DRB MEETING

Tuesday, December 02, 2025 at 7:00 PM
Chris Letourneau Meeting Room and via Zoom
Agenda

SITE PLAN AMENDMENT
Reduction in Setbacks
SA-004-25

SKETCH PLAN REVIEW
Proposed 32-Lot/30-Unit PUD Major Subdivision
SK-006-25

Bowman		HAAVERS	
478 Blair Park Road Williston, Vermont 05495		GEORGIA, VT	
Phone: (802) 879-6331 www.tcevt.com		JOB # 25-227	
		DATE 10/28/2025	
		SCALE 1"=80'	
		DRAWN CMJ	
		SHT 1 OF 1

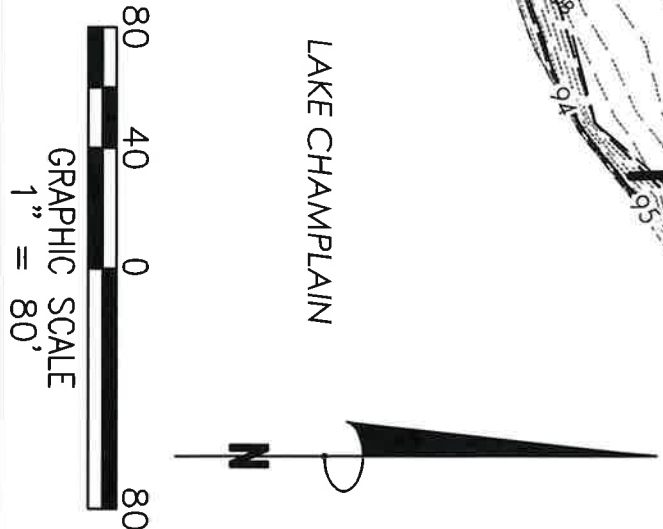
1. **Site Plans:** Applicants have submitted the following maps:
 - Havers Site Plan, 190 Mills Road, prepared by Bowman, dated 10/28/2025.
 - Havers Project Location Map, prepared by ERL, dated 10/28/2025.
2. This project proposes reducing the setback size from 50 feet and 75 feet, as shown on previous subdivision plans, to 20 feet and 50 feet respectively. The proposed setbacks reflect the new 2025 zoning regulations for the Lakeview (LV) zoning district.
3. The property spans both the Lakefront (LF) and Lakeview (LV) zoning districts, with the proposed four-bedroom home to be built exclusively in the Lakeview (LV) zoning district.
4. According to 2.1(E) *Parcels in More Than One Zoning District*. Town of Georgia Development Regulations (October 13, 2025):

C-1

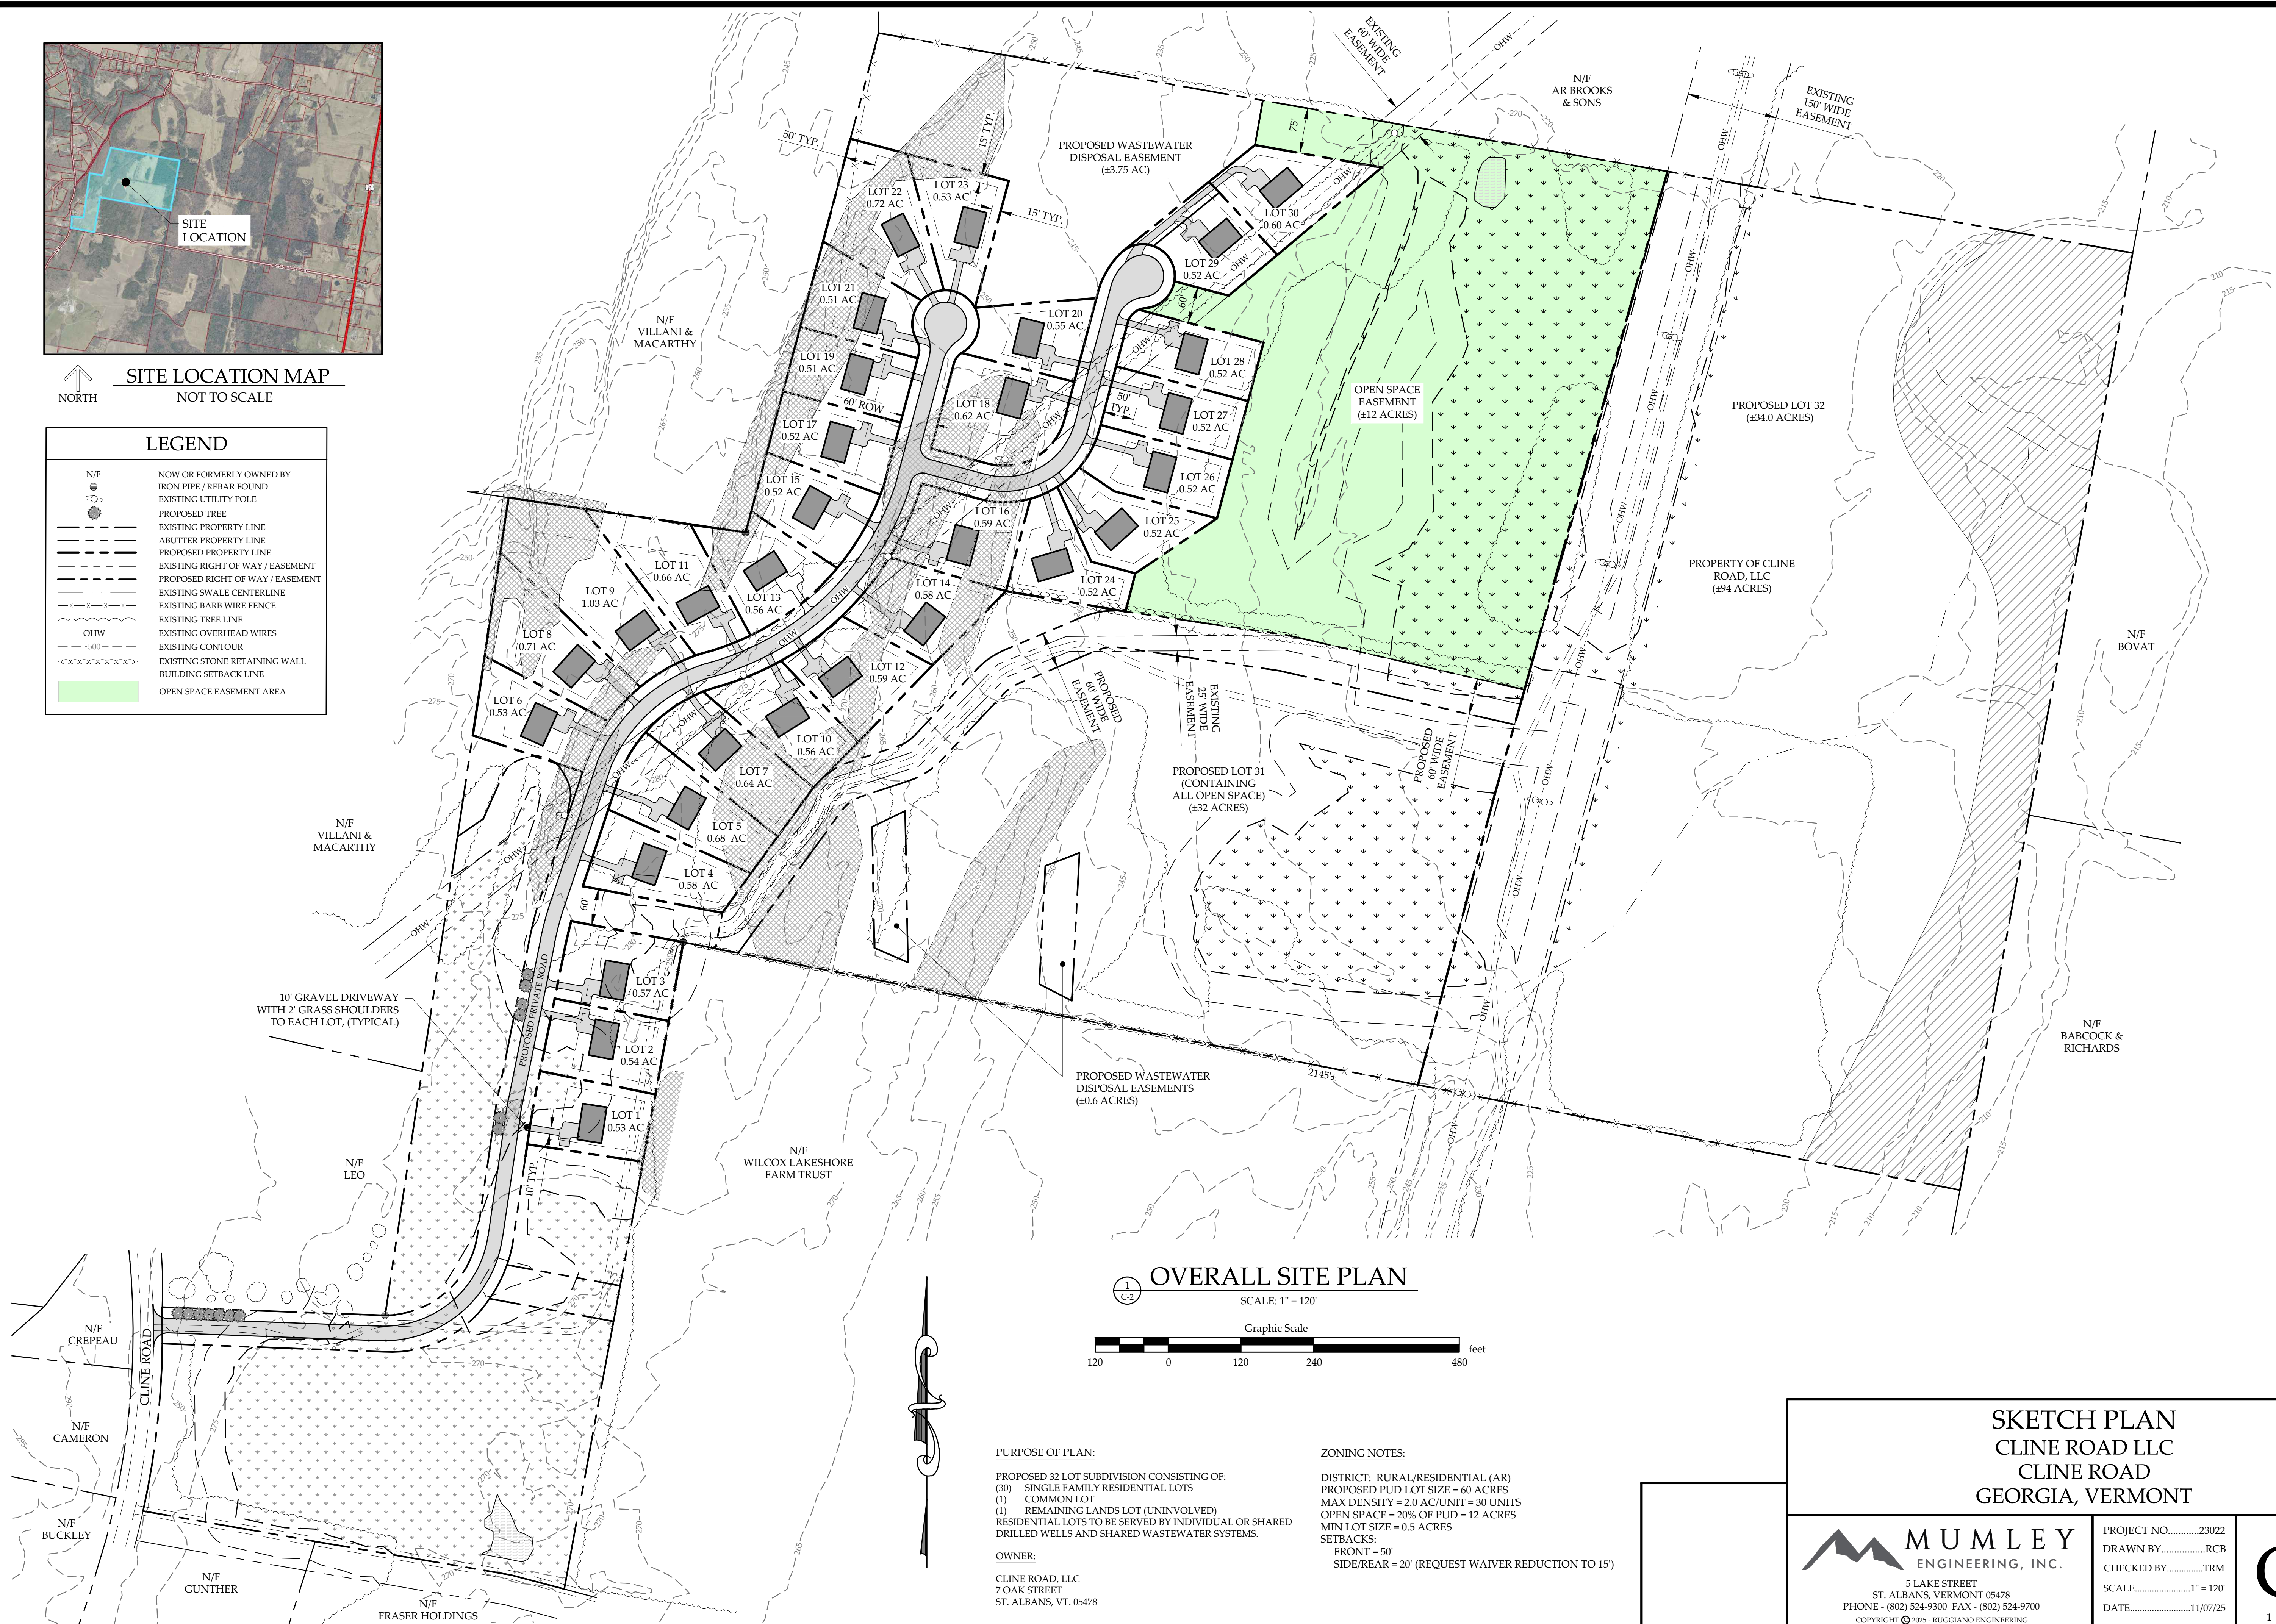
2. ***Waivers Requested:** Applicant is requesting a waiver of the side and rear setbacks in the AR zone to accommodate the PUD properties. Such setback reductions include 20 foot AR setbacks to 15 foot setbacks.
3. **Potential Additional Waivers:**
 - Use of the right-of-way in lieu of road frontage waiver
 - Waiver for Lot 9, over 1 acre maximum lot size
4. **List of plans, sketches, or other information submitted with this application:**

6. **Lot layout.** As proposed, the boundary lines are linear and proposed lots are generally regular in shape. Lot 9 will need a waiver, as maximum lot size in this PUD is 1 acre (see table 6.3, PUD Requirements, 2025 Development Regulations).

12. **Municipal Services.** Applicant has not obtained an Ability to Serve letter from the Fire Chief. A letter will be required for Preliminary Plat Review.

15. **Landscaping Plan and Lighting.** Proposed headlight screening off Cline Road and across from lots 1, 2, and 3 driveways. Lighting was not addressed in the application or project narrative.
